<b>Subject:</b>  ABNORMAL HEATER PERFORMANCE AT IDLE	<b>Bulletin No:</b> 07-001/06
	<b>Last Issued:</b> 3/13/2006

2006 MX-5 vehicles with VINs lower than JM1 NC\*\*\*\* 60 111258 (produced before December 22, 2005)

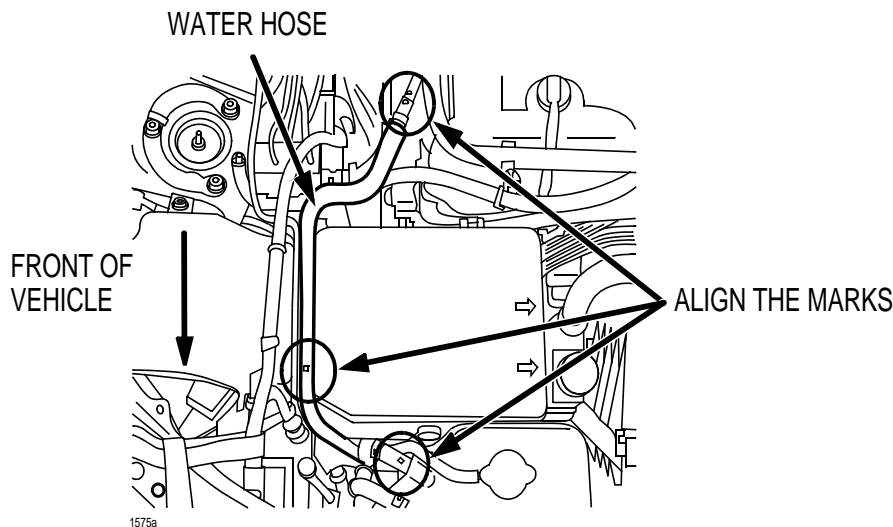
Some customers that park their vehicle on a decline or brake hard during cold engine conditions may experience abnormal heater performance at idle. This condition can be the result of air moving up from the radiator sub-tank through the thermostat housing and becoming trapped in the heater core and/or its supply lines.

To prevent this condition from occurring, the shape of the hose between the radiator sub-tank and the thermostat has been changed. Customers having this concern should have their vehicle repaired using the following repair procedure.

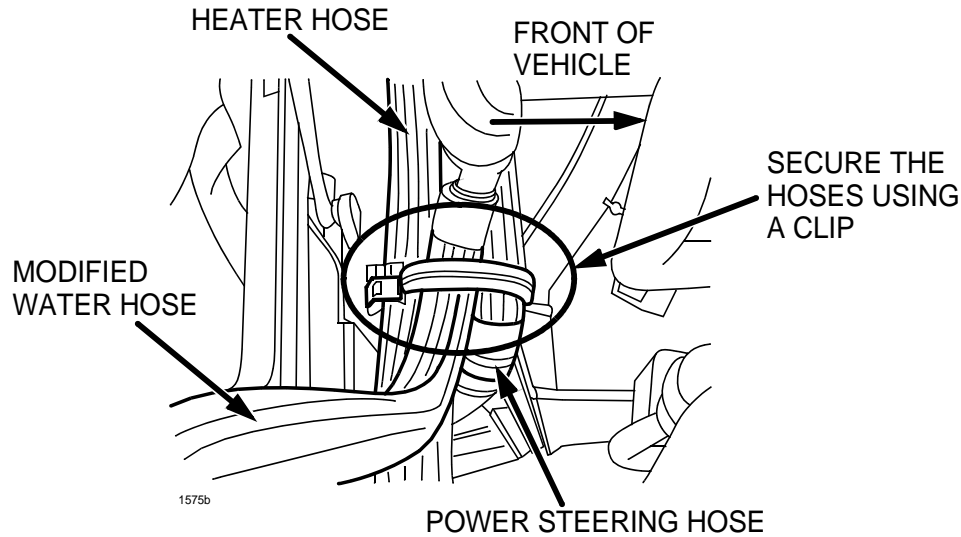
- If the engine is very hot and the water hose is compressed, be careful when removing the cooling system cap. Wrap a thick cloth around it and slowly turn it counterclockwise to the first stop. Step back while the pressure escapes before proceeding with any repair.
1. Verify customer concern.
  2. Remove the water hose.
  3. Align each mark and fit a modified water hose.

4. Using a clip, secure the modified water hose, heater hose and power steering hose together.
